Access Compliance Report

Public Rights-of-Way

Intersection ID: N/A	Main Street: NOBLES_AV	Cross Street: N/A	Location: SE
ADA ID: 6E87CB8178BE	Ramp Type: Perp	Initial Pass/Fail: Fail	Overall Compliance: No
		Severity Score: 12.5

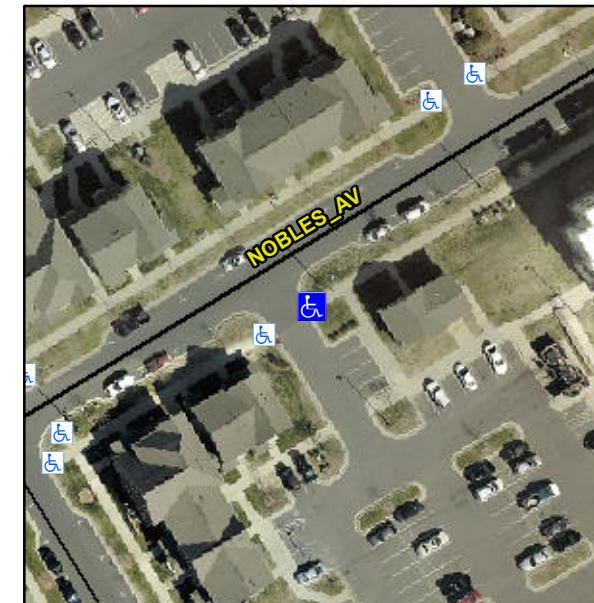
Not Found, R304.2.2

Compliance	Description	Data	Compliance	Description	Data
N/A	Ramp Length (in)	72.0	No	Ramp Slope (%)	10.7
Yes	Ramp Width (in)	70.0	Yes	Ramp XSlope (%)	1.6
N/A	Flare Type LT	N/A	N/A	Flare Type RT	N/A
N/A	Flare Slope LT (%)	N/A	N/A	Flare Slope RT (%)	N/A
N/A	Flare Traversable LT?	N/A	N/A	Flare Traversable RT?	N/A
N/A	Landing Length (in)	N/A	N/A	DWS Provided?	N/A
N/A	Landing Width (in)	N/A	N/A	DWS Contrast?	N/A
N/A	Landing Slope (%)	N/A	N/A	DWS Length (in)	N/A
N/A	Landing X Slope (%)	N/A	N/A	DWS Full Width?	N/A
N/A	Landing Curb? (Y/N)	N/A	N/A	DWS Offset (in)	N/A
N/A	Shared Landing?	N/A			
N/A	Gutter Ponding?	N/A	N/A	Gutter Slope (%)	N/A
N/A	Gutter Lip Ht (in)	N/A	N/A	Gutter X Slope (%)	N/A
N/A	Painted X Walk1?	No	N/A	Painted X Walk2?	N/A
	X Walk 1 Direction	To W		X Walk 2 Direction	N/A
N/A	X Walk 1 Width (in)	N/A	N/A	X Walk 2 Width (in)	N/A
	X Walk 1 Slope (%)	3.7		X Walk 2 Slope (%)	N/A
	X Walk 1 X Slope (%)	1.6		X Walk 2 X Slope (%)	N/A

Remove & Replace Entire Ramp.
